Arlberg Ski Club Limited
Charlotte Pass NSW
PO Box 645
Annerley QLD 4103
Attention: Peter Brooks

Project 215619.00
15 September 2022
R.001.Rev0
MJJ

Preliminary Geotechnical Assessment
Proposed Additions
Arlberg Ski Lodge, Charlotte Pass Village

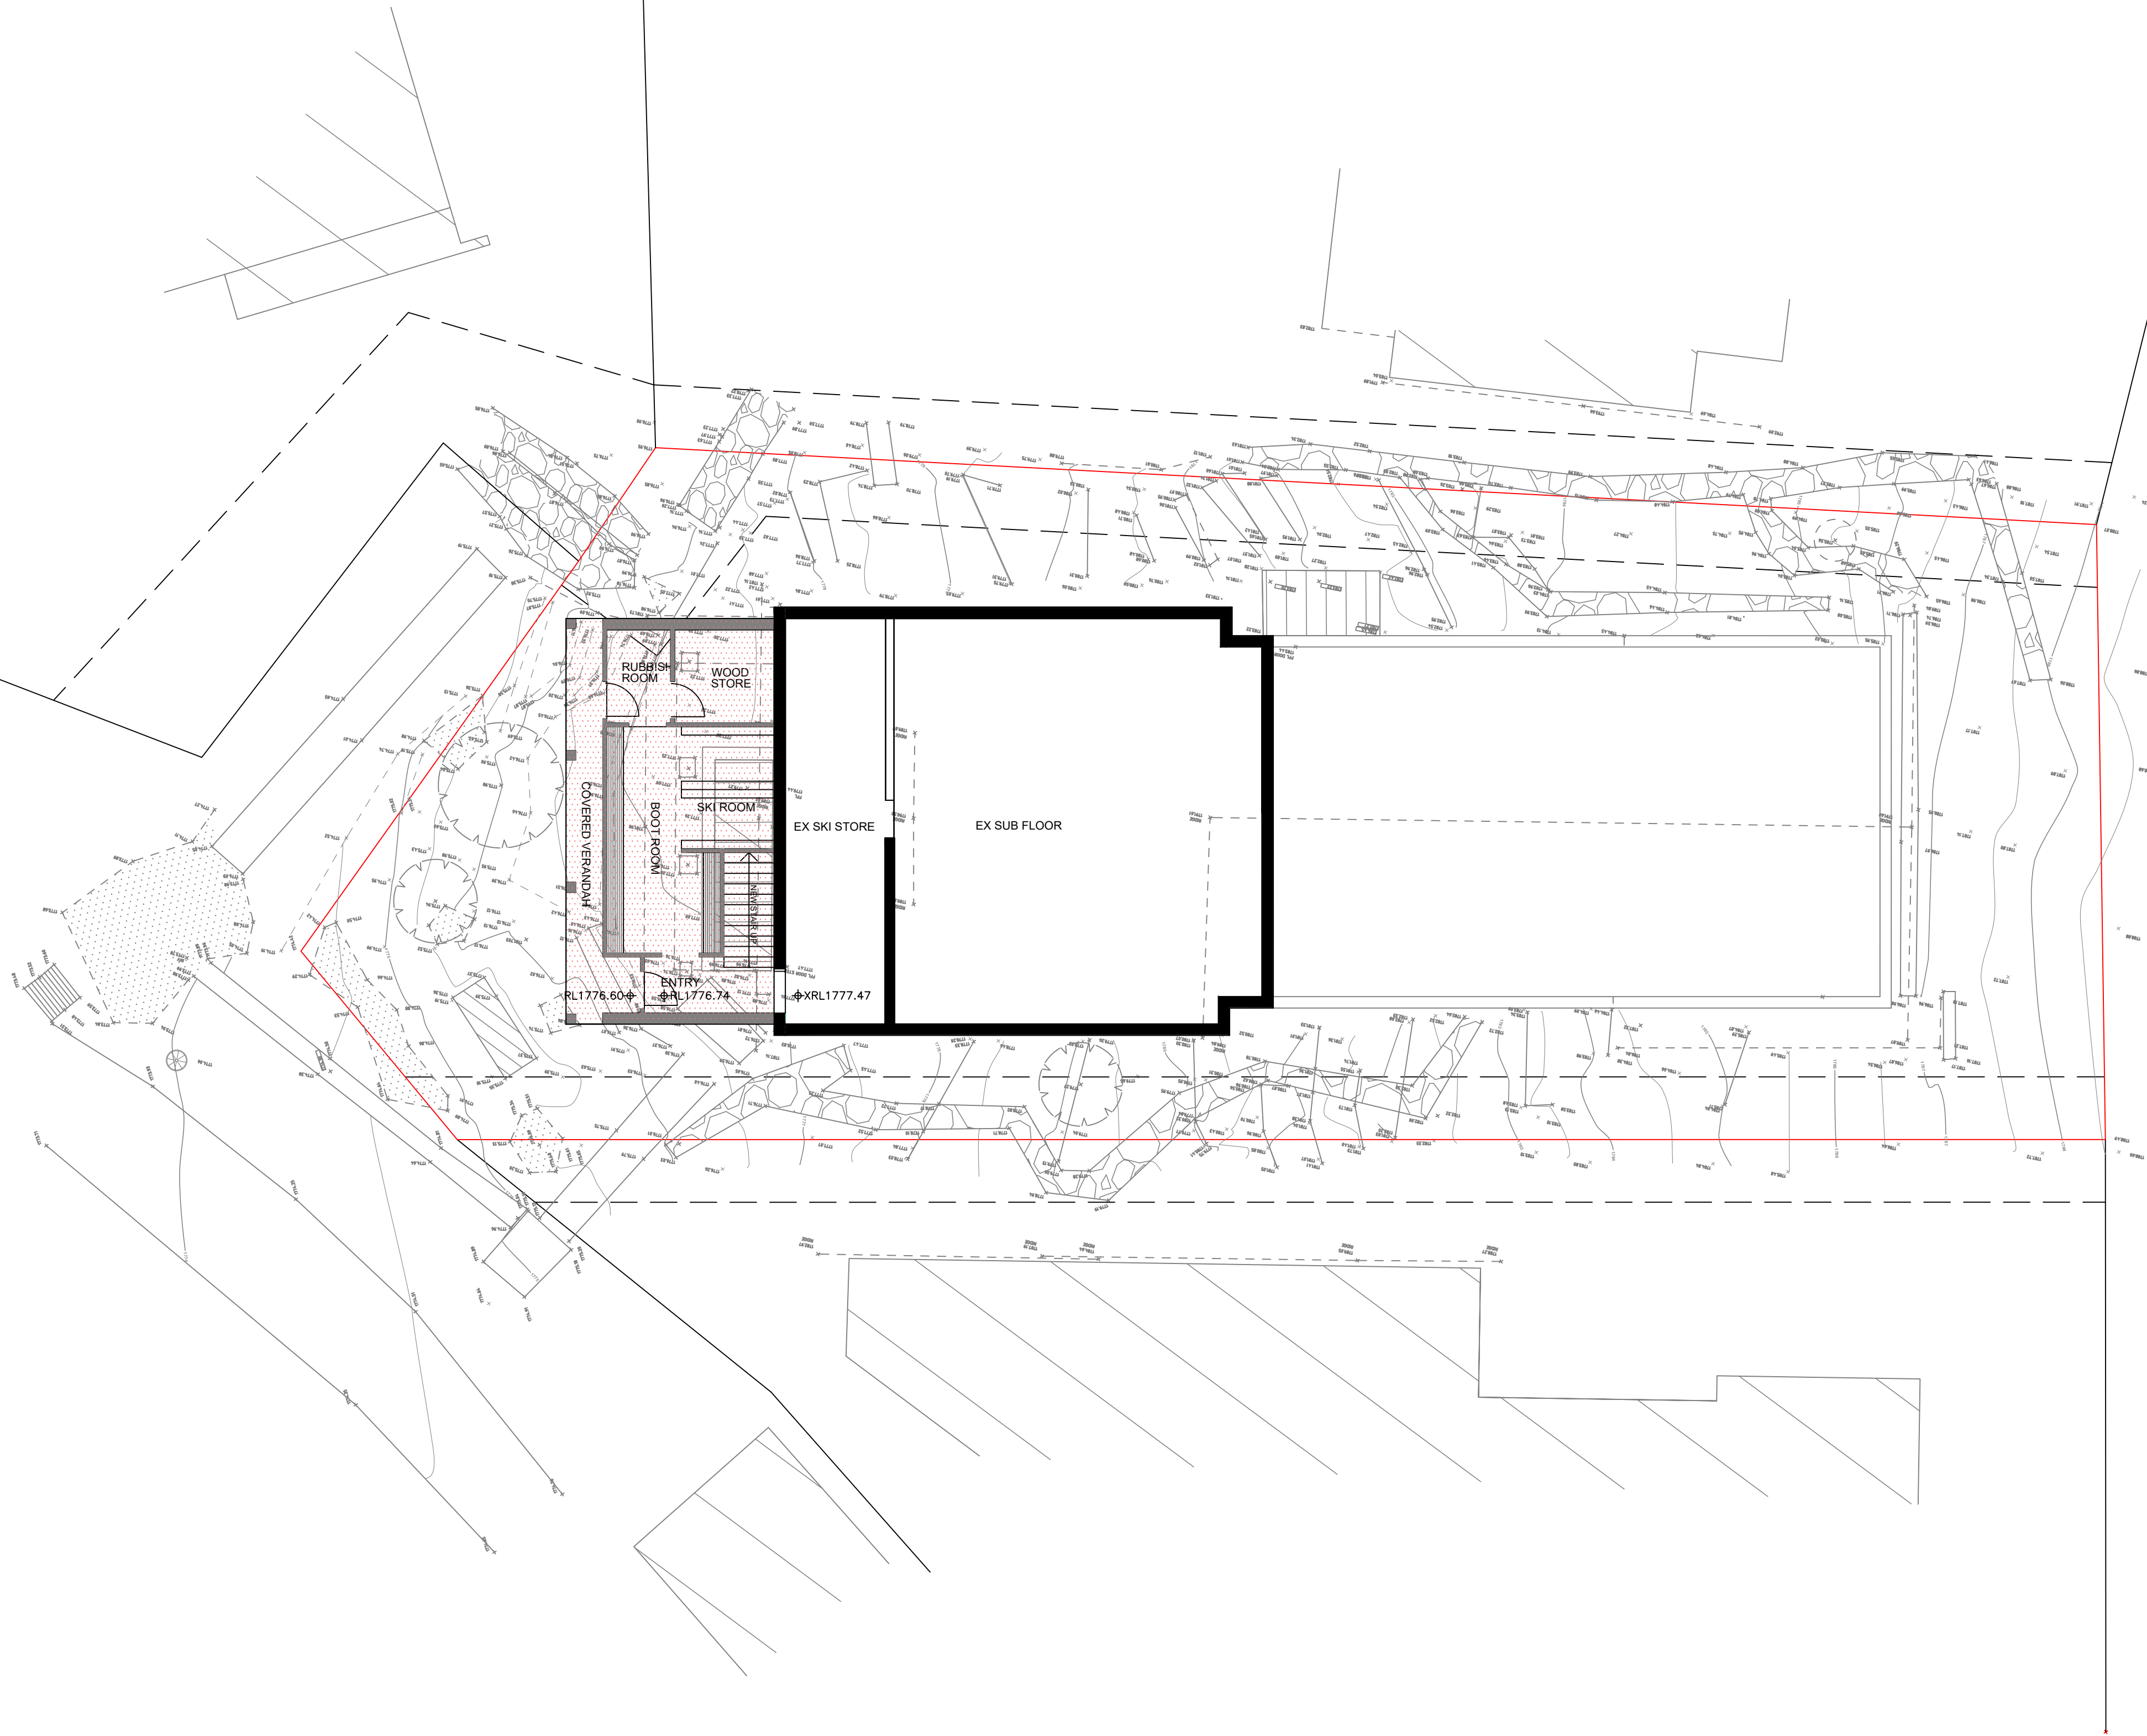
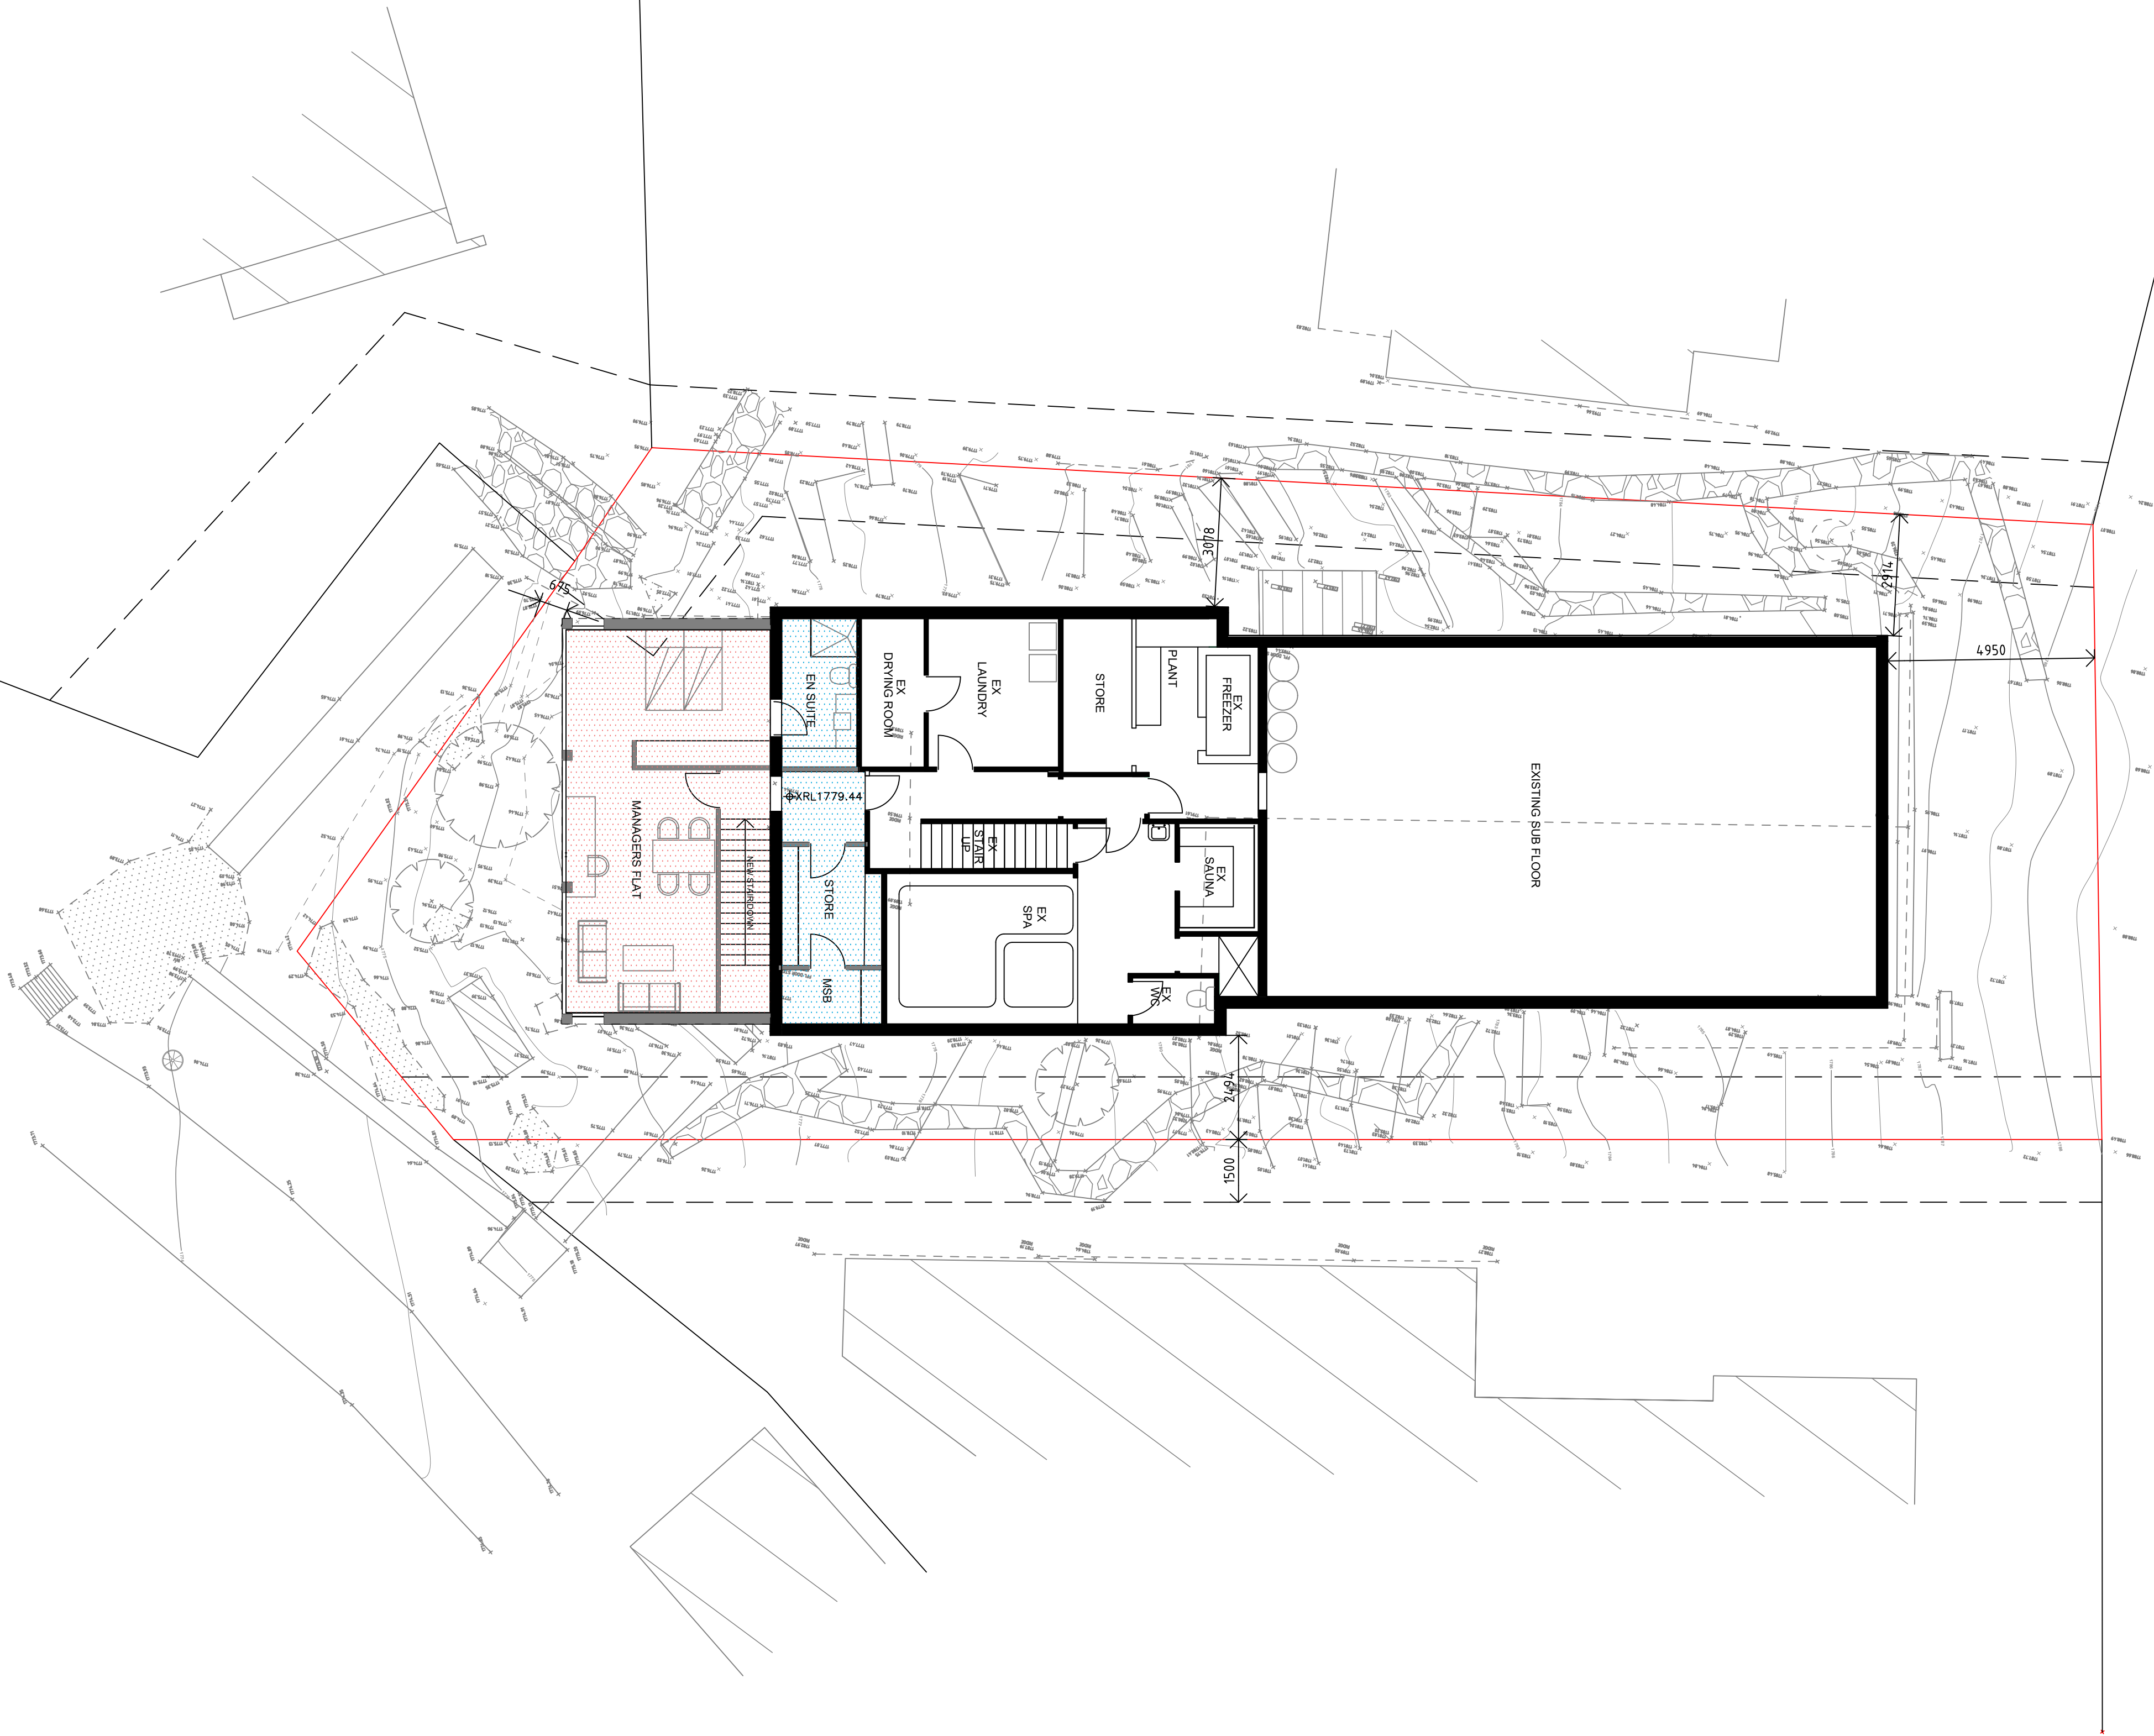
Site works as detailed in Drawings SK1a – SK7a dated 1 January 2021 (see attached drawings) indicate that a maximum depth of cut of 0.7 m and a maximum depth of fill of 0.9 m will be required to facilitate construction levels.

- All loads from the new structure including the lower ground floor slab are to be transferred through the overburden soils (possibly prone to soil creep) to within the weathered rock. A minimum socket of 0.5 m into weathered rock (minimum extremely low strength) is recommended with an allowable end bearing pressure of 300 kPa.
- All new footings must be founded below the zone of influence of any adjacent/existing footings or backfill trenches from buried services or underground storage tanks.
- Where required, fill must be compacted to at least 95% standard dry density ratio within 2 percentage points of optimum moisture content.

- The edges of any site excavation and/or fill required to establish the lower floor area must be supported by engineer designed retaining walls.
- All footing excavations must be viewed by a Geotechnical Engineer to confirm suitability of the founding stratum.
- Site surface drainage or and existing subsurface drainage systems must not be compromised by the proposed works.
- All stormwater and/or sewage that is generated by the new development must be disposed offsite in a controlled manner such that it does not impact the performance of the structure and/or surrounding ground.
